SKEP III Home Office Support Site Visit Report

Consultant	Wahib Medanat Consultant Engineer	Rep No.	22-09082021
Contractor	Dijlah Establishment Constr. Contracting	Tender No.	(11/2019/USAID/SKEP/3/S) Schools for a Knowledge Economy Project (SKEP) - Phase (3) Package (1, 2)
Site Name	Thahr Al Sarow Basic School for Boys- Jerash	Day/ Date	Sat. 09/08/2021
Duration of Project	450 Calendar Days	Total Project Budget	8,314,983.735 JD

Visit Notes

SKEP-3 Memo Form

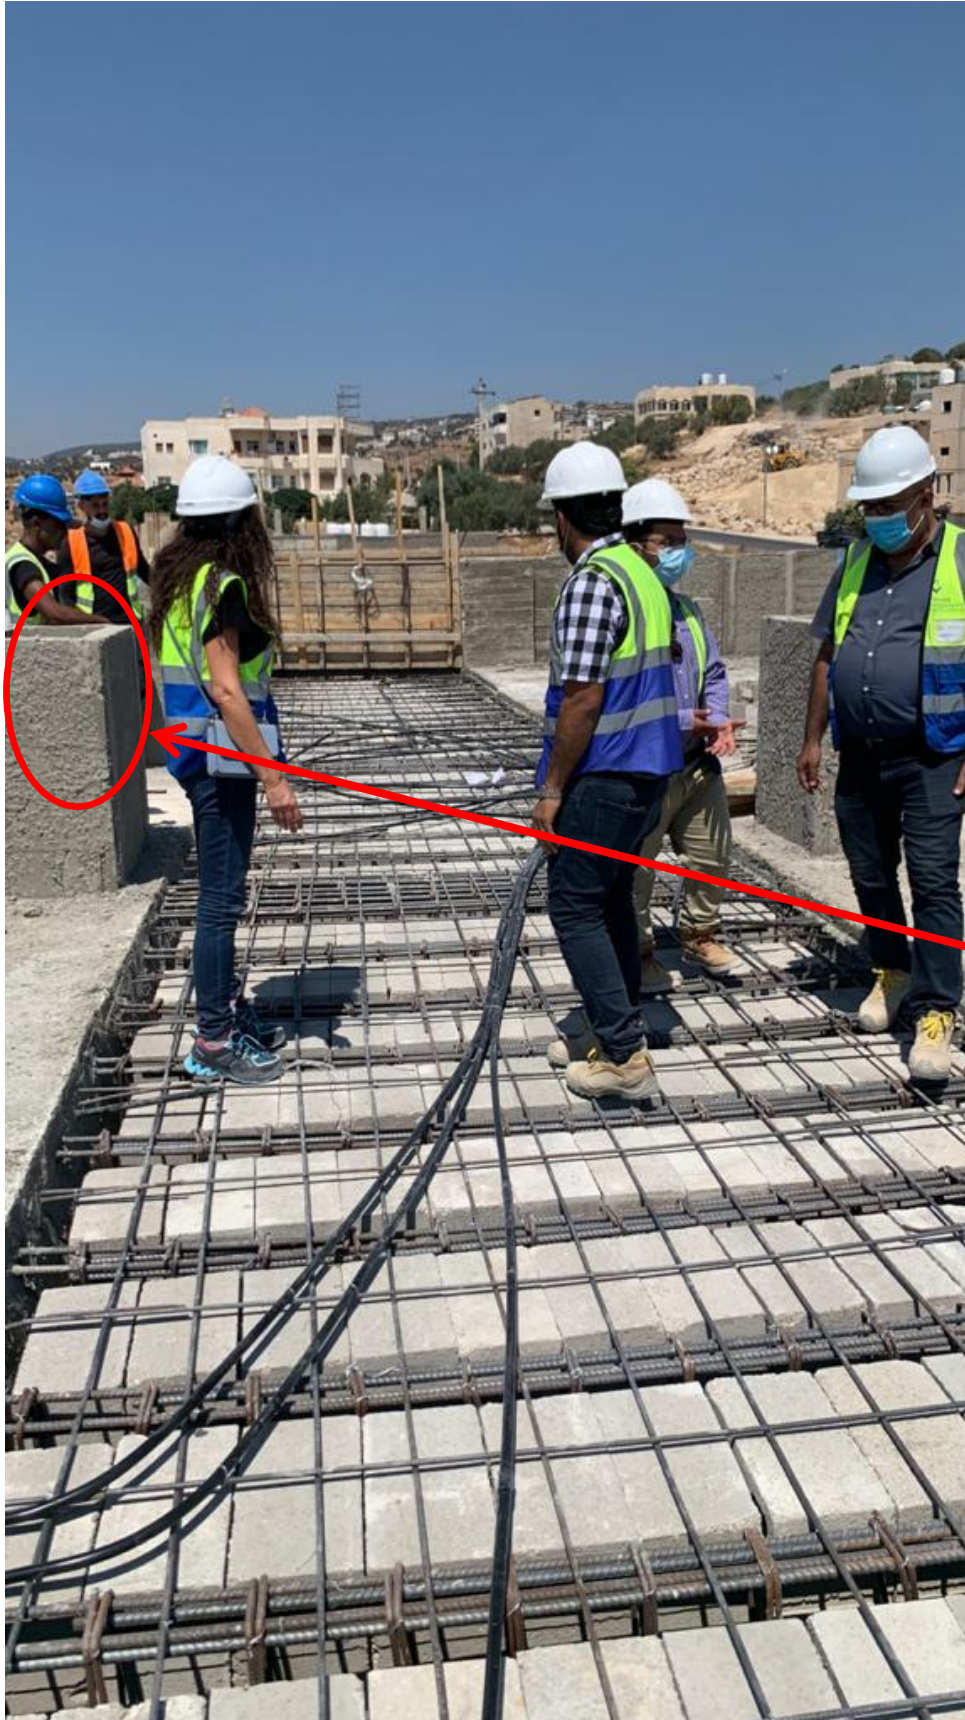
Contractor	Dijlah Establishment Constr. Contracting	Ref. NO.	24
Consultant	Wahib Medanat Consultant Engineers	Tender No.	10/2019/US AID/ SKEP/3/2
Site	THAHR AL-SAROW BASIC SCHOOL FOR BOYS	DATE	09-08-2021
Subject	Removing Failed RSS reports for plaster Accessories (corners and mesh)

Kindly note that due to (RSS) report for plaster Accessories (corners and mesh) dated 17-06-2021 , and your site memo dated (28-06-2021) to remove this material , all this failed quantity removed from our site as attached photos .
